**SOLICITATION AMENDMENT
MODIFICATION DE L'INVITATION**

Title - Sujet HVAC Upgrade Services	
Solicitation No. - N° de l'invitation EP922-210258/A	Amendment No. - N° modif. 003
Client Reference No. - N° de référence du client CFIA EP922-210258	Date 2020-08-30
GETS Reference No. - N° de référence de SEAG PW-\$PWU-183-11872	
File No. - N° de dossier PWU-0-43037 (183)	CCC No./N° CCC - FMS No./N° VME
Solicitation Closes - L'invitation prend fin at - à 02:00 PM on - le 2020-09-08	Time Zone Fuseau horaire Mountain Daylight Saving Time MDT
F.O.B. - F.A.B. Plant-Usine: <input type="checkbox"/> Destination: <input type="checkbox"/> Other-Autre: <input type="checkbox"/>	
Address Enquiries to: - Adresser toutes questions à: Tikhonovitch (RPC), Alex	Buyer Id - Id de l'acheteur pwu183
Telephone No. - N° de téléphone (780) 901-7940 ()	FAX No. - N° de FAX (780) 497-3510
Destination - of Goods, Services, and Construction: Destination - des biens, services et construction:

This amendment has been raised to respond to the following questions:

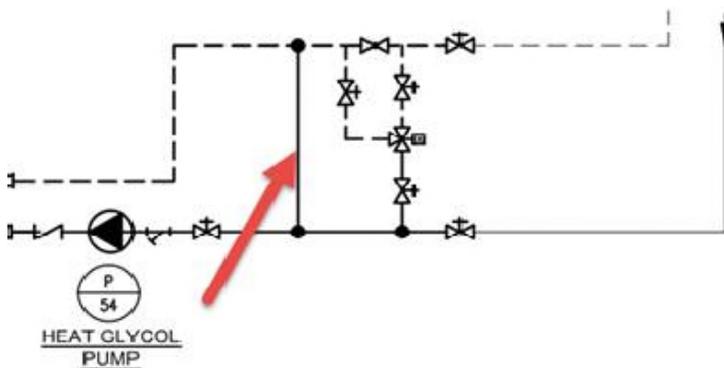
Question 2: 1. On Dwg M404 Detail 2, please provide pipe sizes for the Heating Glycol Schematic SF-15, 16 & 17.

Answer 2: The glycol supply and return branch sizing is as follows. Line sizing has been added to ADD-M02:

- SF-15/16 -> 100Ø GLYS and 100Ø GLYR
- SF-17 -> 50Ø GLYS and 50Ø GLYR
